Access Compliance Report

Public Rights-of-Way

(Curb Ramps)

Intersection ID: 16896	Main Street: BRIARCLIFF_PL	Cross Street: QUEENS_RD_EAST	Location: E
ADA ID: D281812FA51B	Ramp Type: PerpDiag	Initial Pass/Fail: Fail	Overall Compliance: No
Severity Score: 8.75			
Codes/Mitigation Info/Possible Solution		Field Measurements/Component Compliance

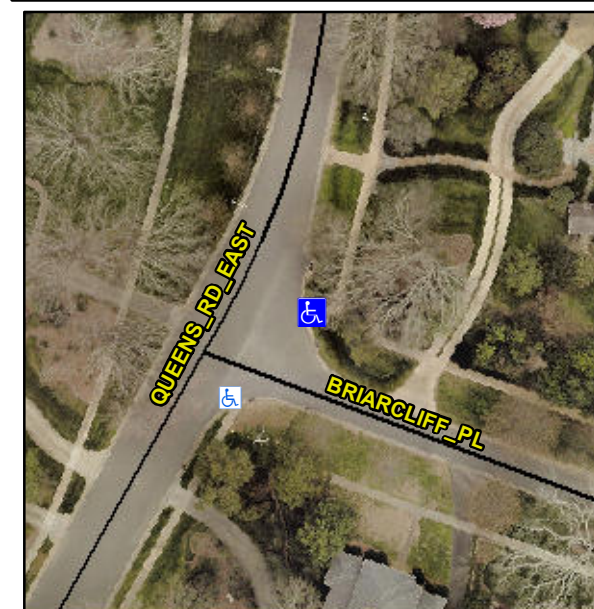
R304.5.1

Compliance	Description	Data	Compliance	Description	Data
N/A	Ramp Length (in)	194.5	Yes	Ramp Slope (%)	7.0
No	Ramp Width (in)	47.0	Yes	Ramp XSlope (%)	0.5
N/A	Flare Type LT	N/A	N/A	Flare Type RT	N/A
N/A	Flare Slope LT (%)	N/A	N/A	Flare Slope RT (%)	N/A
N/A	Flare Traversable LT?	N/A	N/A	Flare Traversable RT?	N/A
N/A	Landing Length (in)	N/A	N/A	DWS Provided?	N/A
N/A	Landing Width (in)	N/A	N/A	DWS Contrast?	N/A
N/A	Landing Slope (%)	N/A	N/A	DWS Length (in)	N/A
N/A	Landing X Slope (%)	N/A	N/A	DWS Full Width?	N/A
N/A	Landing Curb? (Y/N)	N/A	N/A	DWS Offset (in)	N/A
N/A	Shared Landing?	N/A			
N/A	Gutter Ponding?	N/A	N/A	Gutter Slope (%)	N/A
N/A	Gutter Lip Ht (in)	N/A	N/A	Gutter X Slope (%)	N/A
N/A	Painted X Walk1?	No	N/A	Painted X Walk2?	No
	X Walk 1 Direction	To W		X Walk 2 Direction	To SW
N/A	X Walk 1 Width (in)	N/A	N/A	X Walk 2 Width (in)	N/A
	X Walk 1 Slope (%)	3.8		X Walk 2 Slope (%)	2.7
	X Walk 1 X Slope (%)	0.7		X Walk 2 X Slope (%)	2.7

Remove & Replace Curb Ramp With Two New Directional Ramps or Equivalent.
